Product Discontinuation

Touch Sensor

W7ED series

W2GJ series

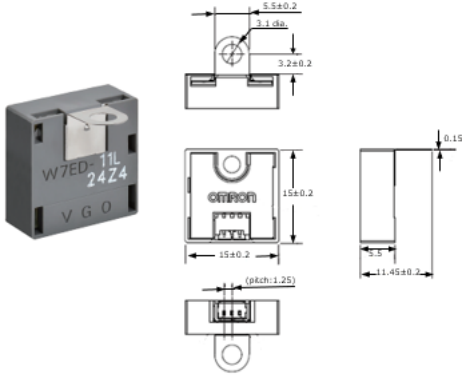
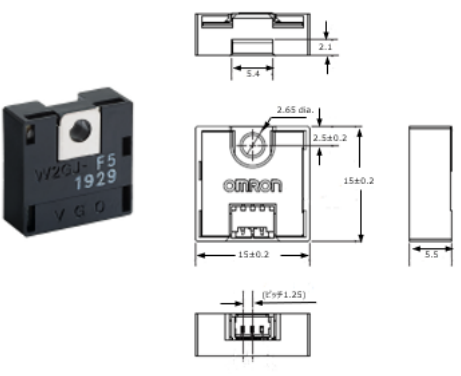
Product discontinuation W7ED-11L	Recommendable replacement W2GJ-F5
<p>The W7ED-11L differs from the W2GJ-F5 in terms of electrode shape. (W7ED-11F and W2GJ-F5 have the same shape)</p>

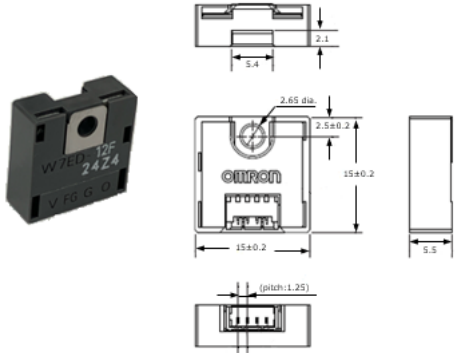
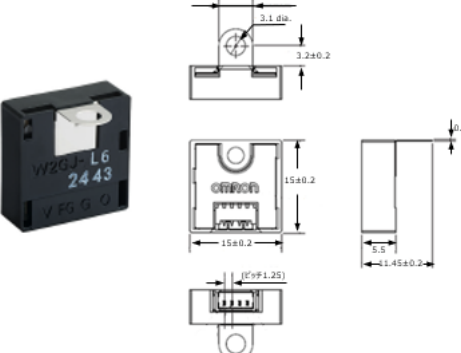
Product discontinuation W7ED-12F	Recommendable replacement W2GJ-L6
<p>The W7ED-12F differs from the W2GJ-L6 in terms of electrode shape. (W7ED-12L and W2GJ-L6 have the same shape)</p>
